Dalraddy to Slochd

Public Exhibitions June 2016
Summary Report

Transport Scotland

September 2016

Junction layout options – Aviemore South (A9 / B9152)

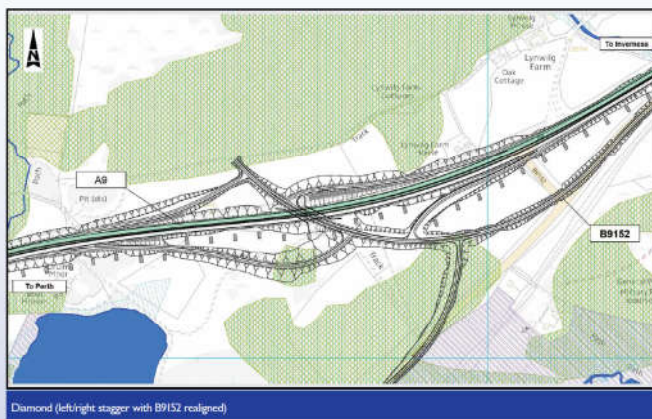
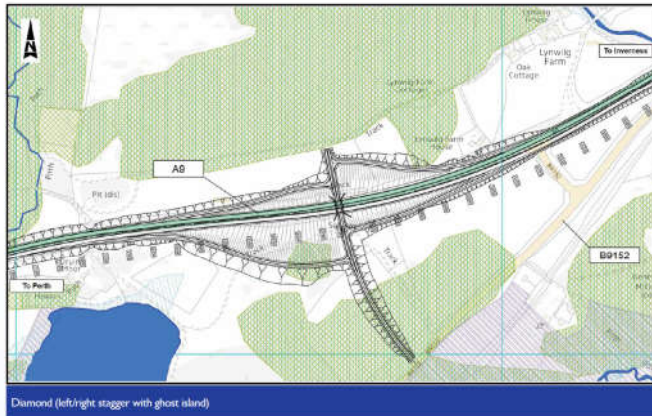
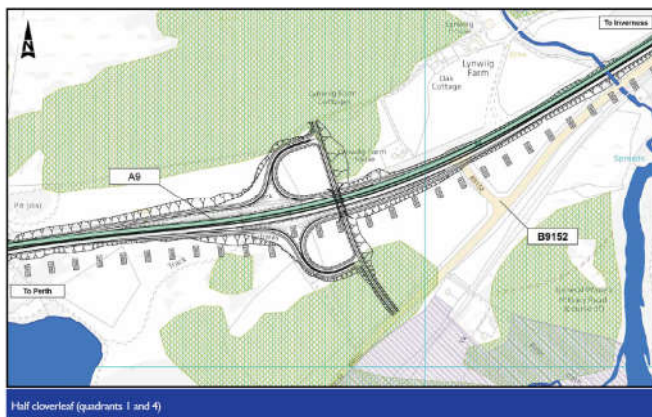
Aviemore_013	<p>Having studied the plans my first choice is Diamond (left/right stagger with B9152 realigned).</p> <p>As the plan states ' B9152 realigned' will this section of the old road be open to local traffic or closed with only access to the North entrance of Kinrara Estate. Since the Speyside Way footpath has been open, an increasing number of people</p>

<p>are accessing the path by parking on the grass verges of the B9152 at the North Kinrara Estate Drive. This could have an impact on whatever plan is chosen.</p> <p>What may seem a minor issue in the big scheme of things - will this affect refuse collection? If the section of road is to be closed hopefully steps would be taken to stop it becoming an overnight parking lay-by.</p> <p>We are greatly concerned that if a junction is created directly onto the A9 further on, the increase in noise, heavy delivery lorries and general traffic will have a negative effect. Aviemore is a rapid growth 'village' with 3 new retail outlets being recently given the go ahead (Marks & Spencer, Aldi & Home Bargains) plus there are approved plans for numerous new houses at Rothiemurchus. We have noticed the increase in traffic, speed and noise from vehicles as they use the B9152 to avoid the present road works at Dalraddy. .</p> <p>We have witnessed numerous accident and near misses at the present A9/B9152 junction. The present B9152 surely cannot cope with the inevitable increase in traffic in the future.</p>

Response	<p><i>Following the A9 Dualling Dalraddy to Slochd public exhibitions in Aviemore and Carrbridge in June 2016 and the closing of the six week consultation period, thank you for taking the time to provide comments.</i></p> <p><i>With regards to Aviemore South, we acknowledge your preference for the Diamond (left/right stagger with B9152 realigned) junction option.</i></p> <p><i>After the Preferred Route has been identified, consideration will be given to specific access arrangements associated with the junction layouts early in the Design Manual for Roads and Bridges (DMRB) Stage 3. We will consult with property owners and The Highland Council to identify the most appropriate treatment of any realigned accesses or side roads.</i></p> <p><i>We thank you for bringing to our attention parking in relation to the Speyside Way.</i></p> <p><i>A Non-Motorised User (NMU) strategy has been developed for the route. Consultation with a wide range of NMU representative groups and members of the public is ongoing with feedback being taken into account. The NMU Access Strategy is available on the Transport Scotland website at</i></p> <p><i>http://www.transport.gov.scot/report/a9-dualling-non-motorised-user-nmu-access-strategy-9068</i></p> <p><i>Again, after a Preferred Route has been identified, facilities for non-motorised users will be considered during DMRB Stage 3.</i></p> <p><i>With respect to any junction options, we confirm that we would look to ensure continued access to the side road network through any proposals, and aspects such as refuse collection and other services will inform the design of specific details around accesses.</i></p> <p><i>The ongoing DMRB Stage 2 develops the potential route and junction layout options, and assesses them against criteria under the headings of engineering, economics, traffic and environment.</i></p> <p><i>We recognise your comments with respect to increases in noise and traffic in general with respect to the options, and confirm that the impacts from all options will be considered as part of the DMRB Stage 2 options assessment.</i></p>

Junction layout options – Granish (A9 / A95)

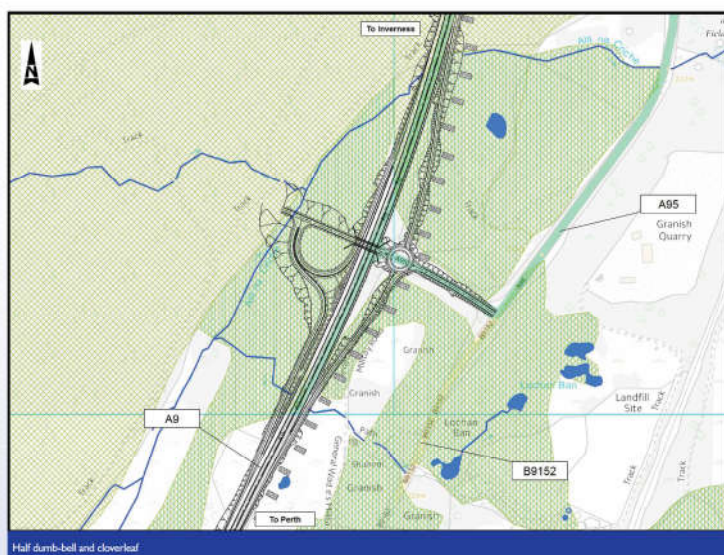
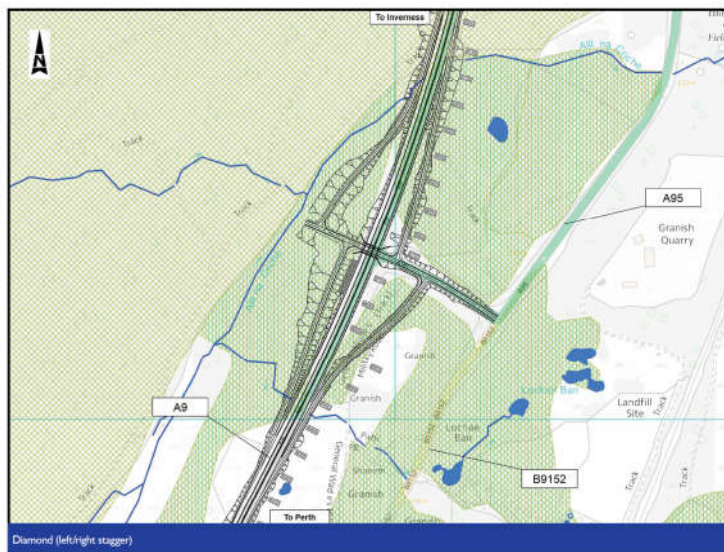
<i>Grantown_001</i>	<p>All 3 suggestions for the Aviemore S junc seem OK.</p> <p>The half dumb-bell and cloverleaf suggested at Granish offers the safer option with less traffic turning right across that going straight.</p> <p>It is Black Mount that puzzles me. There seems to be a desire to make the A938 North into the most important road, when it is used only by local traffic, and very little of that. The suggestion of no links to the South, on or off the A9, seems over restrictive. The half cloverleaf plan again causes traffic leaving the A9 from the North to turn right against traffic leaving the A938 to join the A9 North. A design which utilises the diamond left/right stagger as proposed, but minimises the access to the A938N would be the best solution.</p>
<i>Response</i>	<p><i>Following your attendance at the A9 Dualling Dalraddy to Slochd public exhibition in Carrbridge in June 2016 and the closing of the six week consultation period, thank you for taking the time to provide comments.</i></p> <p><i>We note that you're satisfied with the Aviemore South junction options being taken forward for assessment and your preference for the half dumbbell and cloverleaf layouts at Granish.</i></p> <p><i>We acknowledge your comments in relation to the restricted movements diamond layout option presented for Black Mount junction at the exhibition. The option</i></p>

Response	<p><i>Following your attendance at the A9 Dualling Dalraddy to Slochd public exhibition in Carrbridge in June 2016, thank you for taking the time to provide feedback.</i></p> <p><i>With regards to the junction layout at Granish, we note your preference for the half dumbbell and cloverleaf layout.</i></p> <p><i>In terms of the potential diamond layout at Granish, this layout, and indeed all the layouts along the A9 dualling project, are based on fully compliant junction layouts as set out in the design standards of the Design Manual for Roads and Bridges (DMRB) and applicable to the Category 7a dual carriageway for the new A9 dual carriageway trunk road.</i></p> <p><i>With regards to Black Mount, the option consisting of restricted movements is being considered as the traffic turning information currently available indicates that very few vehicles travelling northbound on the A9 turn right onto the A938 or the local road at this location and similarly very few vehicles from the A938 and local road turn left (southbound) on to the A9. The impacts to traffic turning as well as any implications to the operation and maintenance (such as the gritting operations you noted) of the trunk and side road networks will be fully considered as part of the Design Manual for Roads and Bridges (DMRB) Stage 2 assessment.</i></p> <p><i>We note your preference for the half-cloverleaf at Aviemore South. Proximity to property is one of our key criteria when assessing the junction layout options and we can confirm that we are consulting with all potentially affected landowners.</i></p> <p><i>The ongoing DMRB Stage 2 develops the potential route and junction layout options, and assesses them against criteria under the headings of environment, engineering, traffic and economics.</i></p> <p><i>Upon completion of the development of the options, and their assessment and through ongoing consultation with stakeholders in DMRB Stage 2, the Preferred Route Option will be selected. The intention is to announce the Preferred Route Option in early 2017.</i></p>

Junction layout options – Black Mount (A9 / A938)

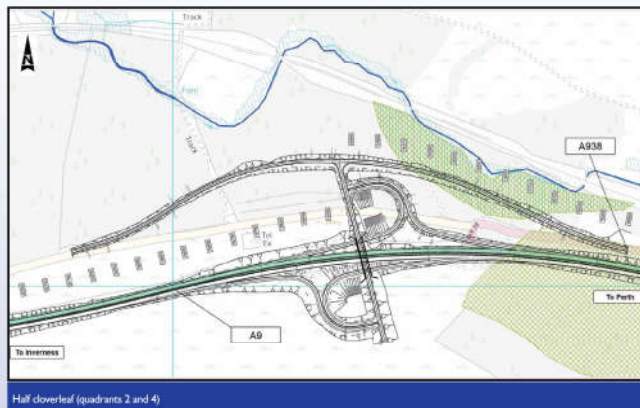
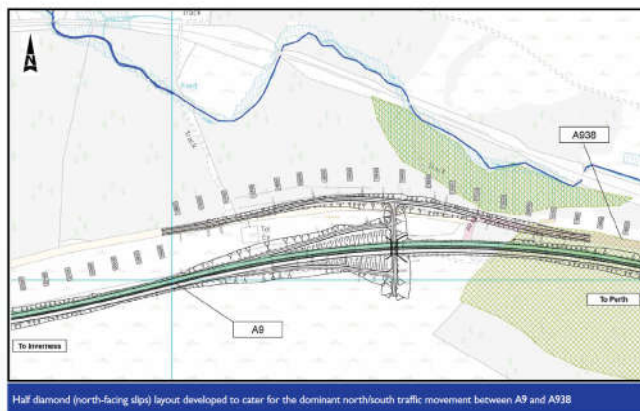
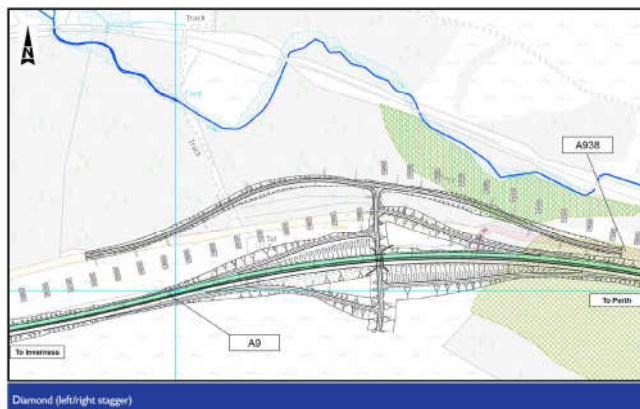
Reference	Comments
Carrbridge_008	<p>The question is would the proposed re-alignment of the A938 which is in line with the old A9 just north of the present junction, would motorists decide to drive straight on up the old A9 if they knew there was access on the new dualled A9 further on say at Slochd compared to slowing down, crossing the bridge over the dual carriage way and then head north on the slip road towards Inverness.</p> <p>Junctions: We would like to thank the A9 Dualling team for giving us the opportunity to call at your drop-in sessions of which we can pass on our concerns and information which may help with the proposals of the realignment of the A9 and our access and exit to the A9. Black Mount (A9 / A938) half diamond (north facing slips).</p> <p>It is hoped that Highland Council will install some sort of traffic calming soon and certainly before any work commences at Blackmount junction and also close off the north access at Slochd junction.</p> <p>The Blackmount access (A9 / A938) The option of half diamond north facing slips proposal will be the option that suits provided the present access and Slochd junction is closed off.</p>

Response	<p>Following the A9 Dualling Dalraddy to Slochd public exhibitions in Aviemore and Carrbridge in June 2016 and the closing of the six week consultation period, thank you for taking the time to provide comments.</p> <p>We note your preference for the half diamond restricted movements at Black Mount.</p> <p>With regards to the T-junction connection from the A9 to the A938 and unclassified road to Slochd, we recognise that the proposed layouts create a change in priority which favours limited through movement from A938 towards Slochd. We can confirm that these layouts are based on fully compliant junction layouts as set out in the design standards of the Design Manual for Roads and Bridges (DMRB) and applicable to the Category 7a dual carriageway for the new A9 dual carriageway trunk road. The removal of the T-junction to form a free flow link from the A938 to the A9 has been considered. However, to achieve compliant geometry for such a link design to meet current design standards, results in a significant deviation to the existing line of the A938 with resultant impacts and interface with the railway line, forestry, water courses and potentially deep peat deposits. It has therefore been discounted from further consideration as it does not present any advantage when compared to the options presented at the June exhibitions.</p> <p>The ongoing DMRB Stage 2 develops the potential route and junction layout options, and assesses them against criteria under the headings of environment, engineering, traffic and economics.</p> <p>Upon completion of the development of the options, and their assessment and through ongoing consultation with stakeholders in DMRB Stage 2, the Preferred Route Option will be selected. The intention is to announce the Preferred Route Option in early 2017.</p>
